City of FRESNO

CITY OF FRESNO – ADDENDUM NO. 1

RIVER WEST FRESNO EATON TRAIL EXTENSION, PHASE 1

BID FILE NUMBER: 12700455

Know what's **below.**
Call before you dig.

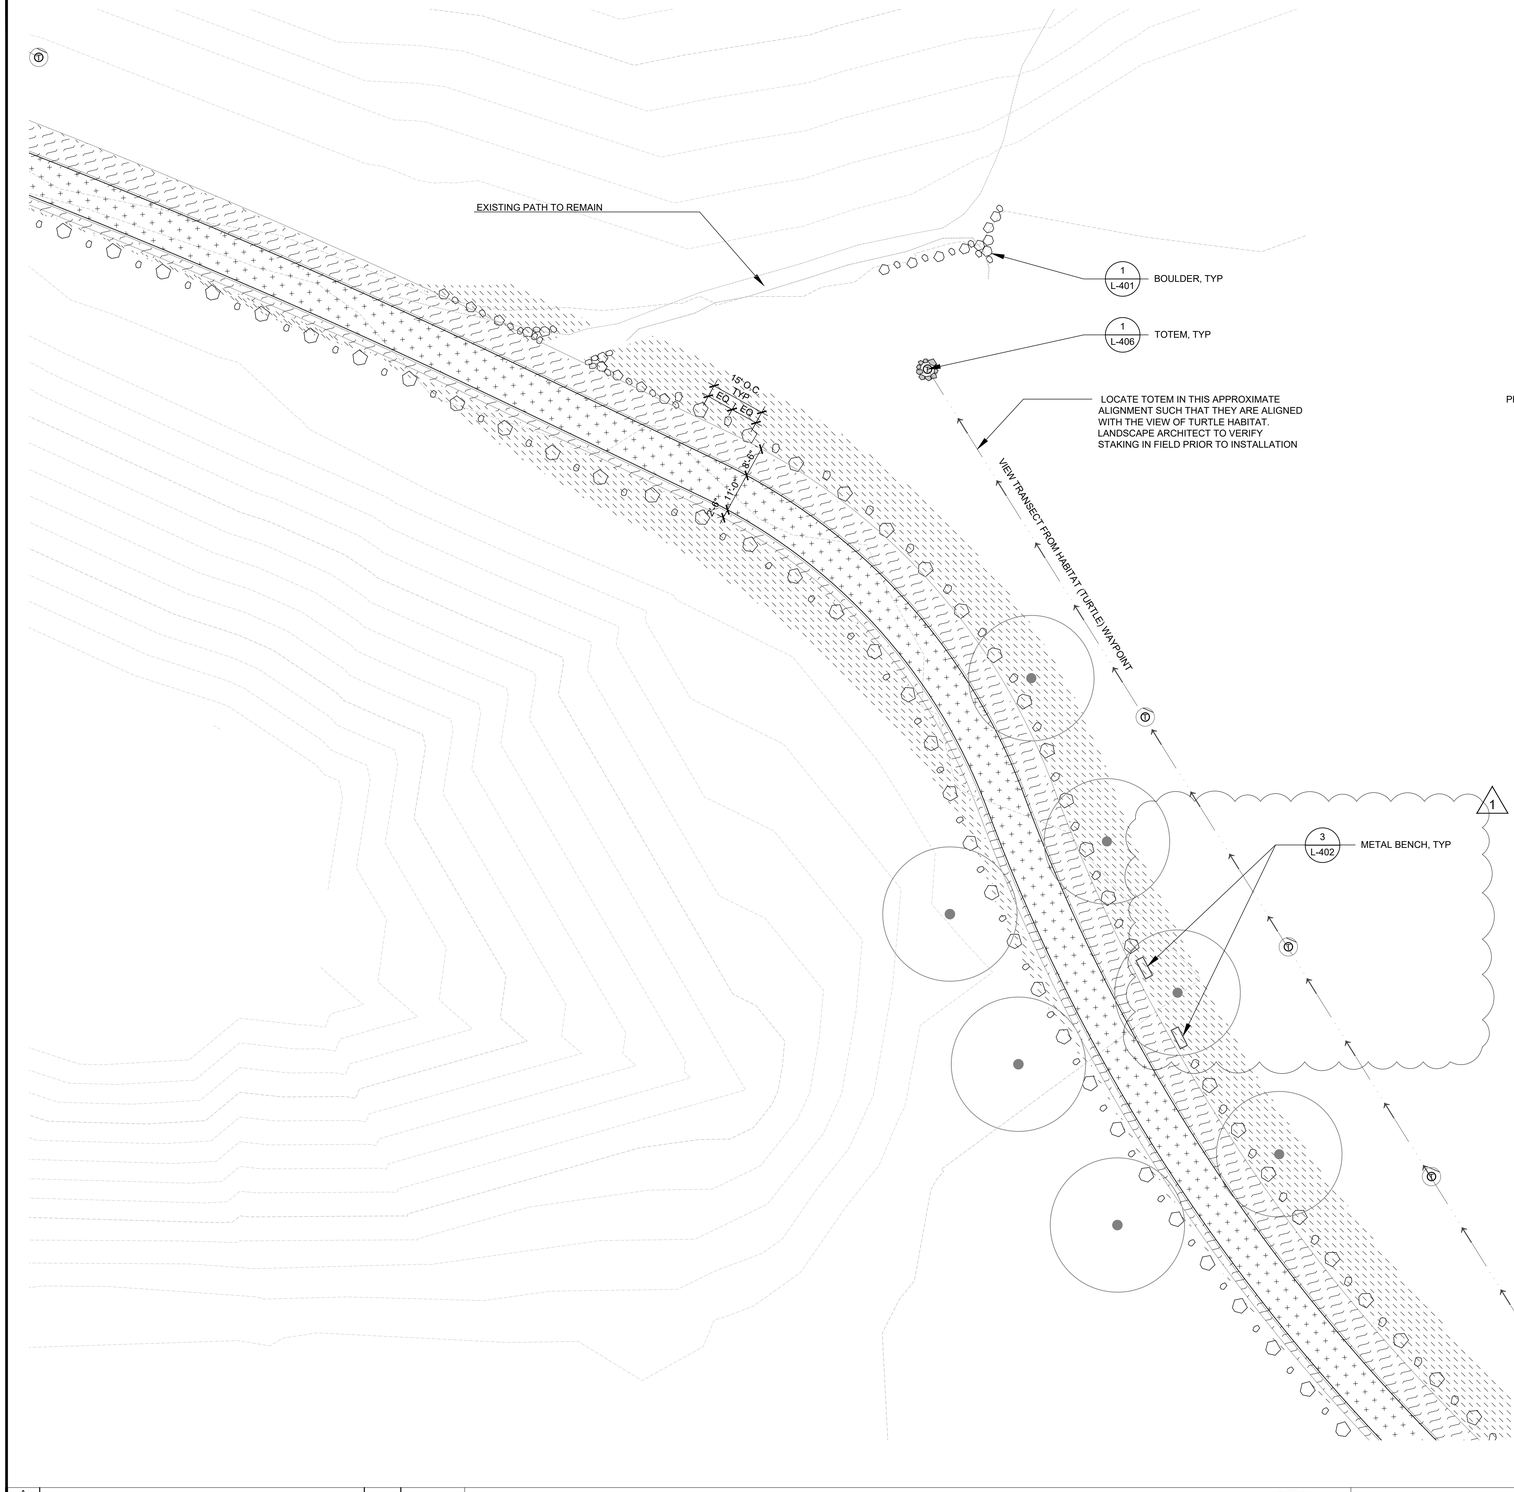
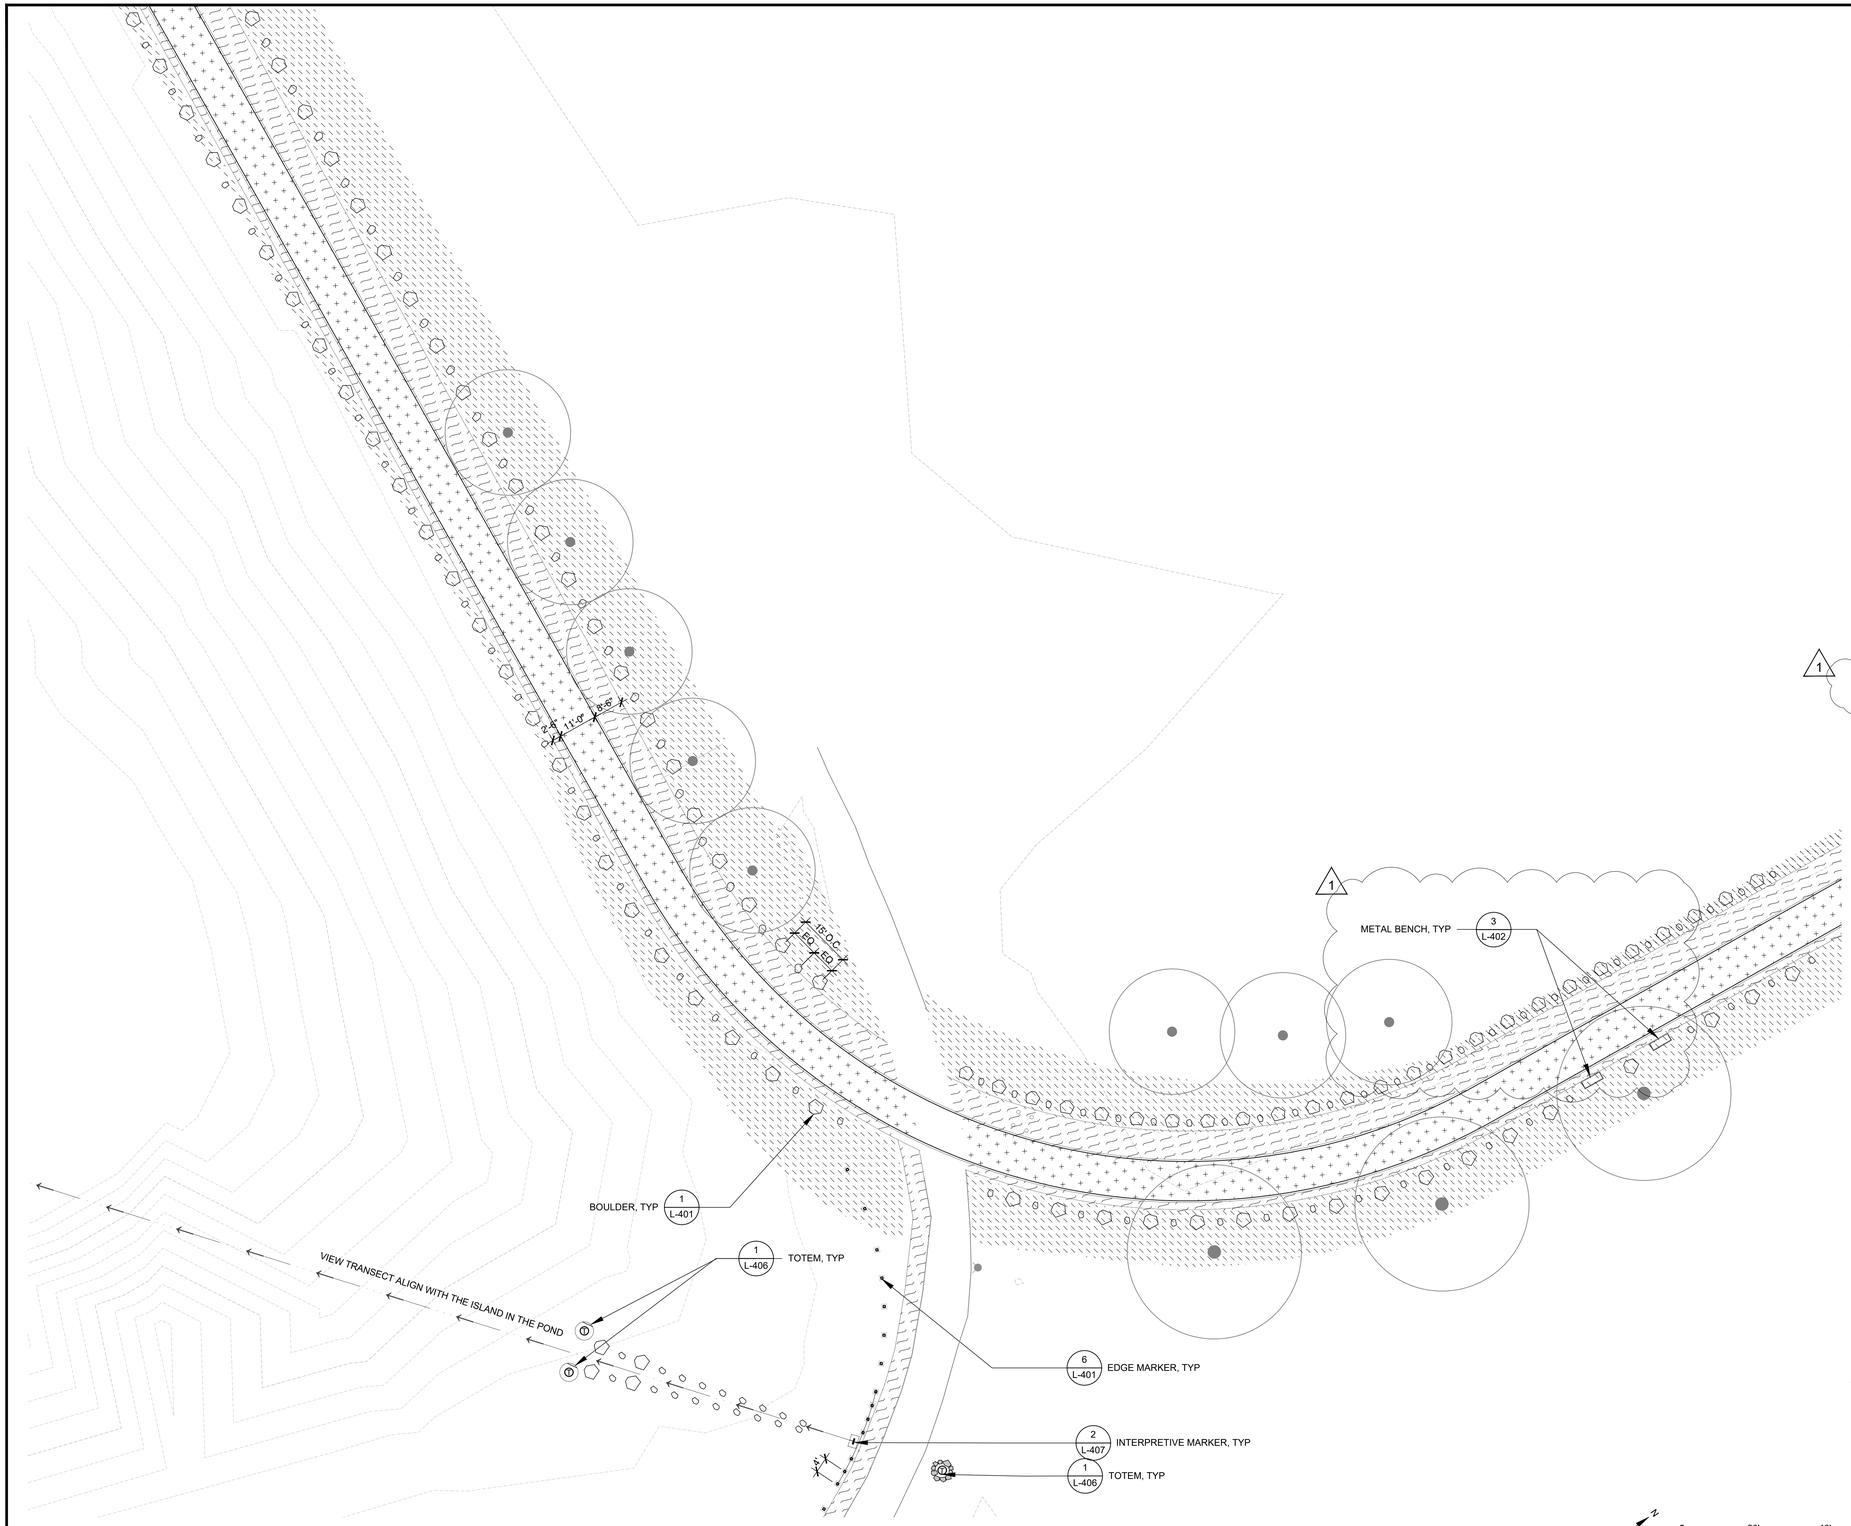
On Material Plan L-101 through L-110 shows quantity for Metal Bench is 15 EA, but on legend and specifications shows quantity for Metal Bench is 47 EA. Please confirm quantity for Metal Bench.

8. Modification to Material Plans on Plan Sheet 15-E-14656 to 15-E-14666:

- Remove and Replace Sheets No. 15-E-14656 to 15-E-14666, Sheets 75 to 85 of 133, entirely with Addendum No. 1 Drawing Sheets No. 15-E-14656

(Addendum No. 1) to 15-E-14666 (Addendum No. 1), (clouded and marked ADDENDUM NO. 1) which modifies the number and location of metal benches.

Response:
There is a total of 23 Metal Benches. See updated Addendum No. 1 Drawing Sheet No. 15-E-14656 (Addendum No. 1) to 15-E-14666 (Addendum No. 1), 75 to 85 of 133, with changes clouded and marked ADDENDUM NO. 1, which clarifies the number and location of metal benches. See updated Specifications Division I Bidding and Contract Documents, Bid Proposal page 1.3 (Addendum No.1) and Division VI Technical Specifications page 6.12 (Addendum No.1) Bid Item Description for Bid Item 29 - Site Furnishings.
